UNITED STATES PATENT AND TRADEMARK OFFICE

| APPLICATION NO. | FILING DATE | FIRST NAMED INVENTOR | ATTORNEY DOCKET NO. | CONFIRMATION NO. | |
|-------------------------------|-----------------------------------|----------------------|-------------------------|------------------|--|
| 10/082,492 | 02/22/2002 | Gene Samson | 271/231 | 4234 | |

| | Application No. | Applicant(s) | | | |
|--|---|--|--|--|--|
| Office Action Summary | Examiner | Art Unit | | | |

DETAILED ACTION

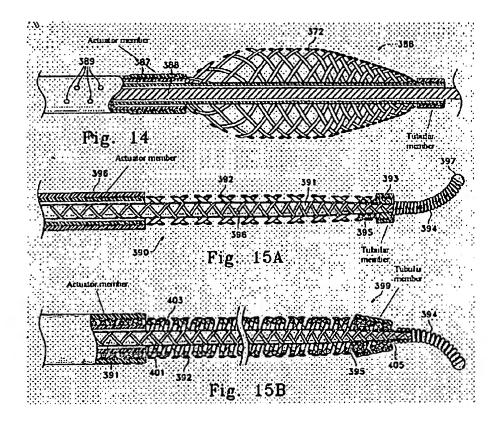
Engelson et al. disclose a device comprising a core wire, e.g. 388 01-391 with a coil tip coupled to a distal end of the core wire (see for example Figures 14, 15A, 15B). The device further comprises a cage, e.g. 372 or 392. The cage has a distal end, proximal end, first deployment shape, and a second expanded shape. The first and second shapes are different from each other. The device further has a tubular member (see Figures 14, 15A, and 15B) coupled to a distal end of the cage assembly and the tubular member surrounds a distal portion of the core wire proximal to the coil tip.

The device also has an actuator member, as shown above, that has a first position and a second position, and is located proximally to the cage and substantially coaxial about the core wire. When the actuator member is in a first position the cage is in a deployment shape and when the actuator member is in the other position, the cage is in the second expanded shape. The core wire is freely moveably axially through the cage assembly (see col.13, lines 43-44). The tubular member can be considered a bushing. The device can further include an inner coil, e.g. 401, surrounding the core wire within the cage assembly. The inner coil inner coil does not pass distally on the core wire. Engelson et al. does not disclose a cage assembly including a proximal cage and a distal cage. It would have been obvious to one having ordinary skill in the art at the time the invention was made to construct the device of Engelson et al. having a

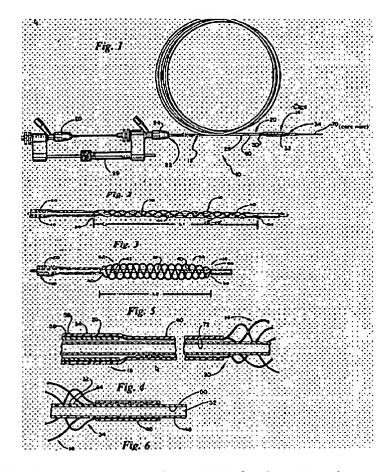
Schmaltz et al. disclose a device comprising a core wire or guidewire 70, a cage 14, a tubular member 46, and an actuator element 18 (see Figures 1-5 below). The cage 14 has a distal end, proximal end, first deployment shape, and second expanded shape, wherein the shapes are different from each other (see Figures 2 and 3 below). The tubular member 46 is coupled to the distal end of the cage assembly and it would surround a distal portion of the core wire or guide wire (see Figures I and 6 below). The actuator element has first and second positions and it is located proximal to the cage and it is substantially coaxial about the core wire (see Figure 1). The core wire or guide wire is freely movable axially through the cage (see col. 8, lines 30-35). The core wire or guidewire may be a standard guidewire. The tubular member is considered a bushing and is made of a thermoplastic material, e.g. polyolefin (see col. 7, lines 1 5- I 7). The device further includes inner coils or bands, e.g. 40 and 41, made from radiopaque materials (see col. 6, lines 32-34 and 59-64). The inner coils or bands do not pass distally on the core wire.

Schmaltz et al. disclose the claimed invention except for the core wire or guidewire having a coil tip at its distal end and a cage assembly including a proximal cage and a distal cage. Crittenden et al. disclose a core wire or guidewire with a coil tip at its distal end (see Figure 2). The core wire or guidewire is steerable wherein the coil tip can be adjusted without requiring removal of the guidewire from the patient (see abstract). It would have been obvious to one skill in the art at the time the invention was made to use with the device of Schmaltz et al. a core wire or guidewire that is steerable instead of one that is not in view of Crittenden et a1., so that the guide wire can be adjusted without requiring removal of the guidewire when it is inserted into the patient. It also would have been obvious to one skilled in the art at the time the invention was made to
